My Garage at Northcrest PPR PCD No. PPR-21-036

Re: **My Garage at Northcrest: Traffic Memorandum
El Paso County, CO**

**DEVIATION REQUEST
AND DECISION FORM**

Attachment I
Site Plan

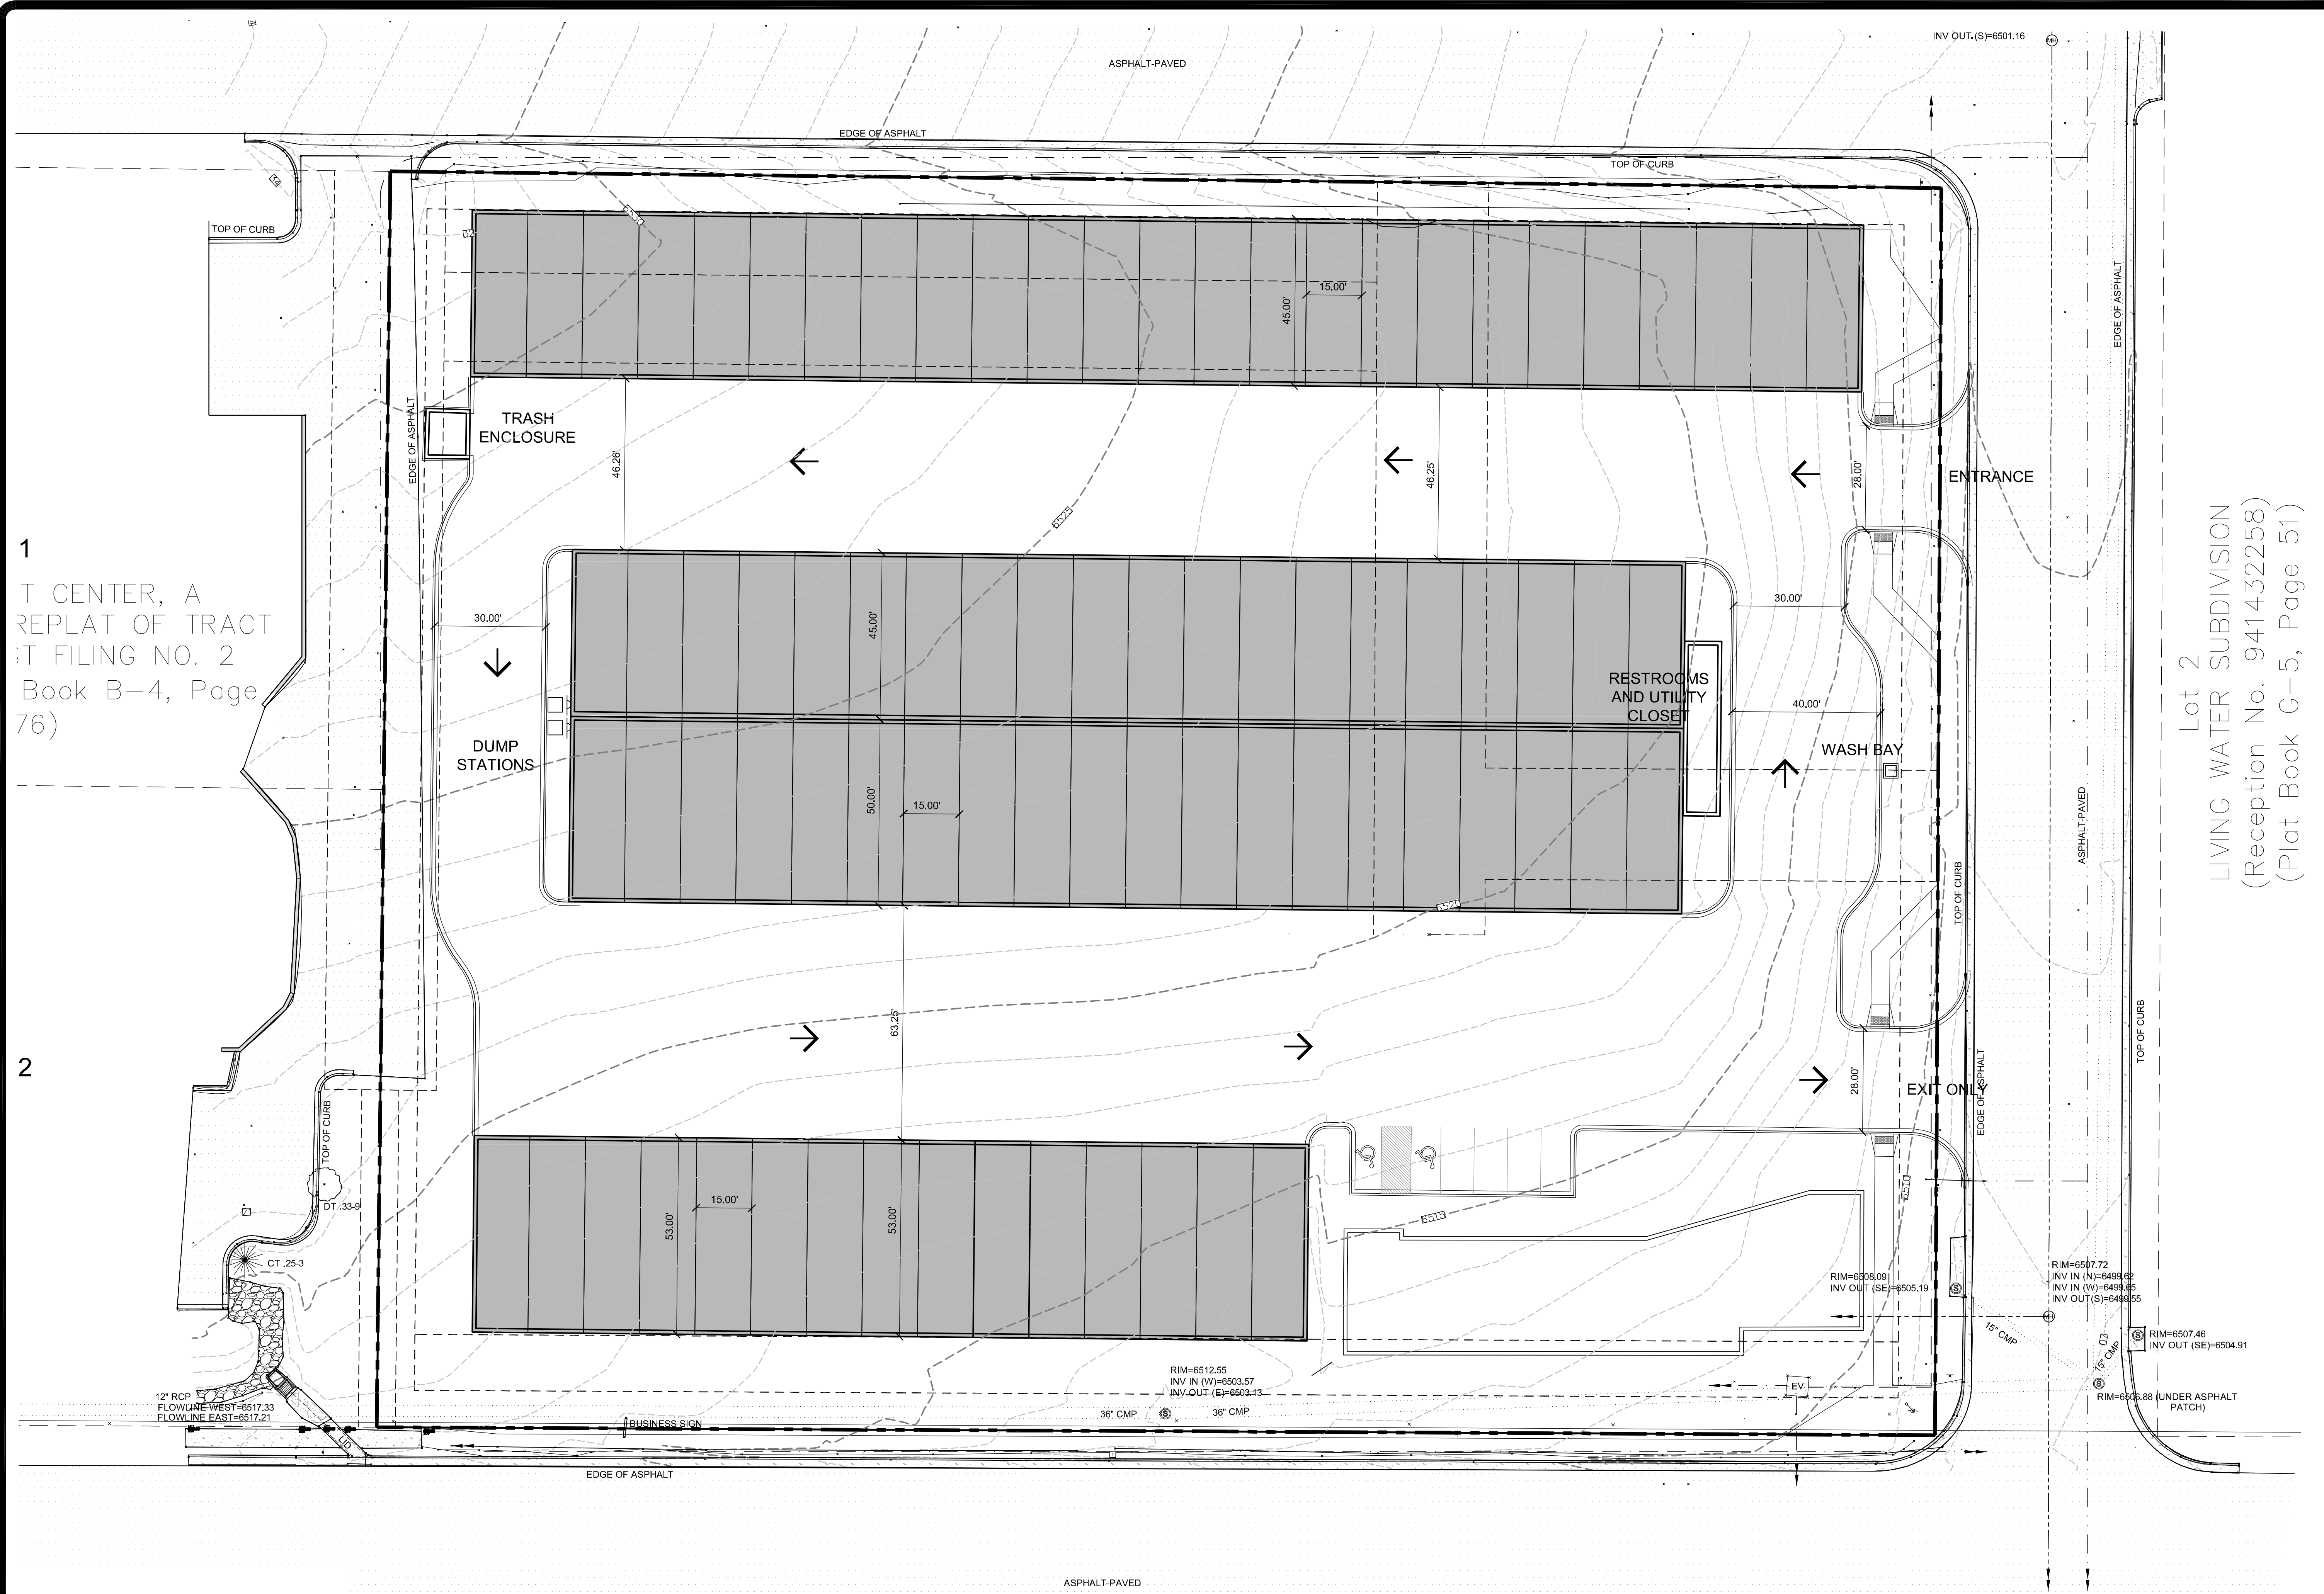
Briefly discuss the deviation requested
